| Project Title: | SJ2 |
| Document Title: | Report of Conversation- K Garrison, USFWS and C Watson, CEC- March 25, 2021 |

| PROJECT TITLE: San Jose Data Center | | Docket: 19-SPPE-04 |
| SUBJECT: CDFW Notice of Preparation Comment Letter and other Biological Issues | | |

References

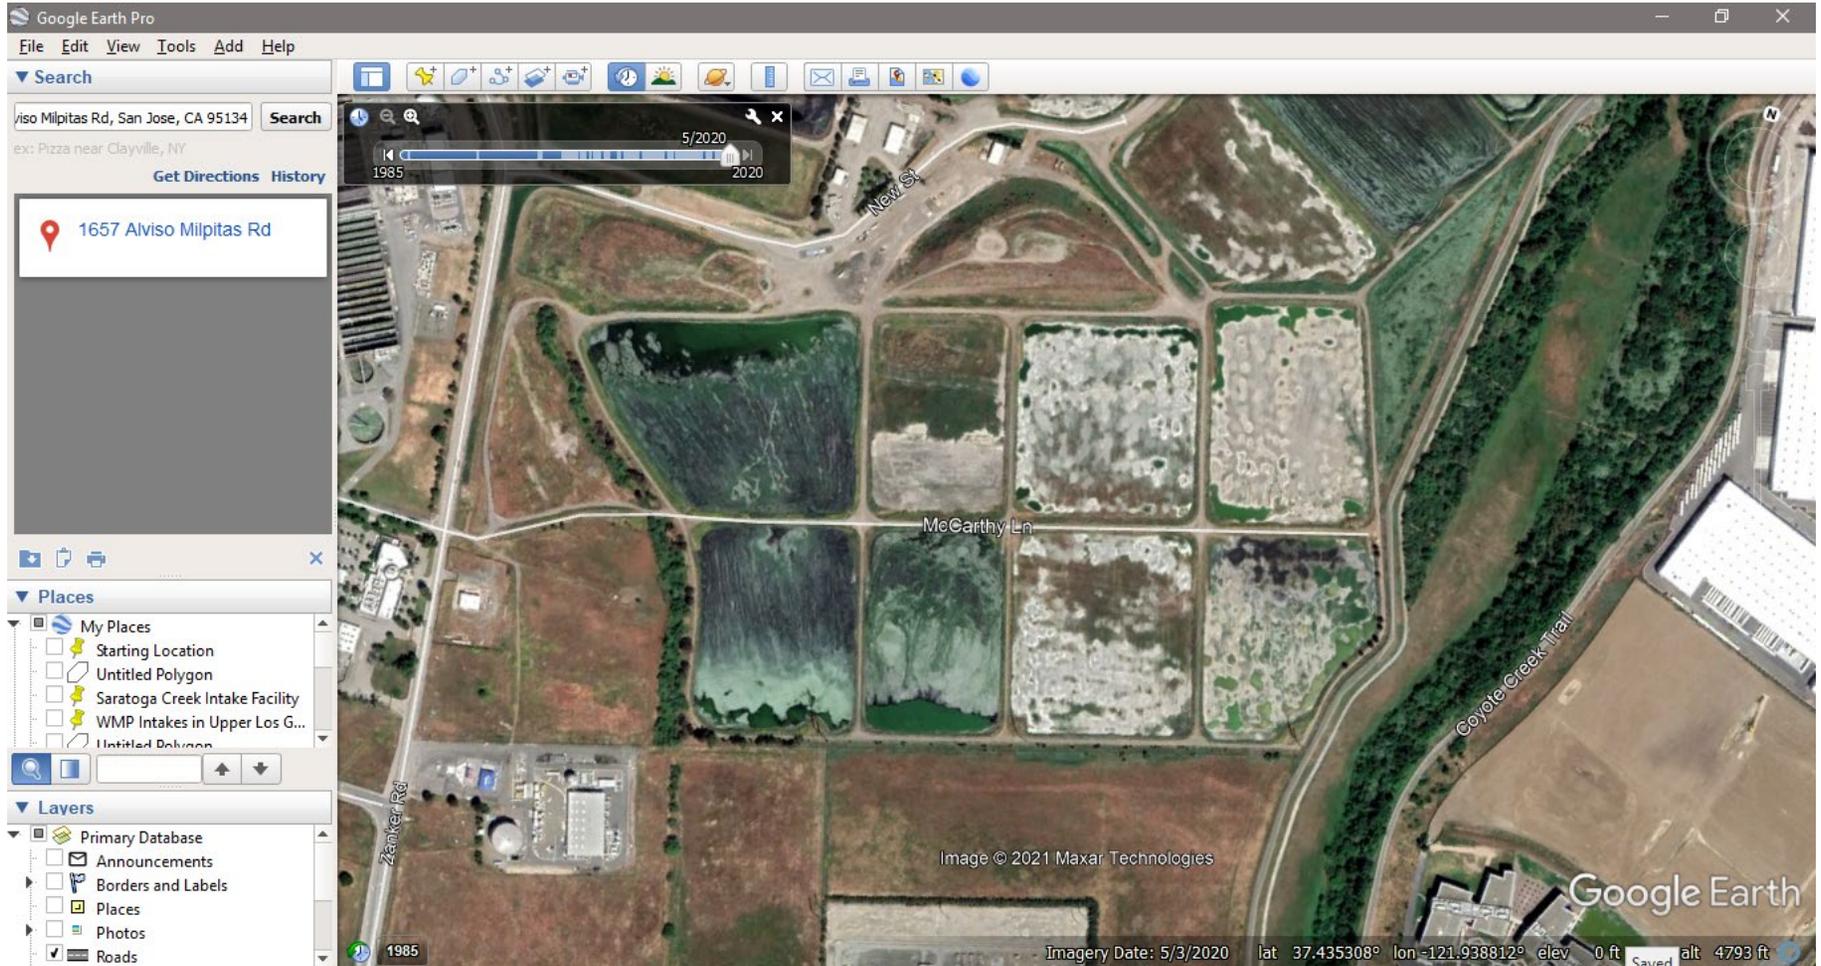
Regarding SMHM, this species is known to be present in tidal bay habitats (the presence of the CNDDDB occurrences support this) and also seasonal diked wetlands. Between those known habitats and CNDDDB occurrences and the project site, there are many, as you call them, "treatment ponds" that are contiguous with bay habitats from south San Francisco Bay to the northern border of the project site (see attached with a print screen of the CNDDDB occurrences and diked seasonal wetlands polygon I made using the measure tool). In looking at Google Earth aerials through time, it looks like the wetlands north of the project site have vegetation growth and other times they are mowed or maybe graded (print screens in the attached document). SMHM are not found in only pickleweed. There was an old study that had said this, but we now know that they are found in variable types of vegetation (see attached studies).

I am not saying this is highly suitable habitat. It may be marginal at best. However, we do need to be careful since they are fully protected and CESA endangered (and also ESA endangered). Maybe SMHM habitat is present to the north of the project site, maybe it is not. That is why a habitat survey is recommended, per my NOP letter. If habitat is not found, then avoidance measures are not needed.
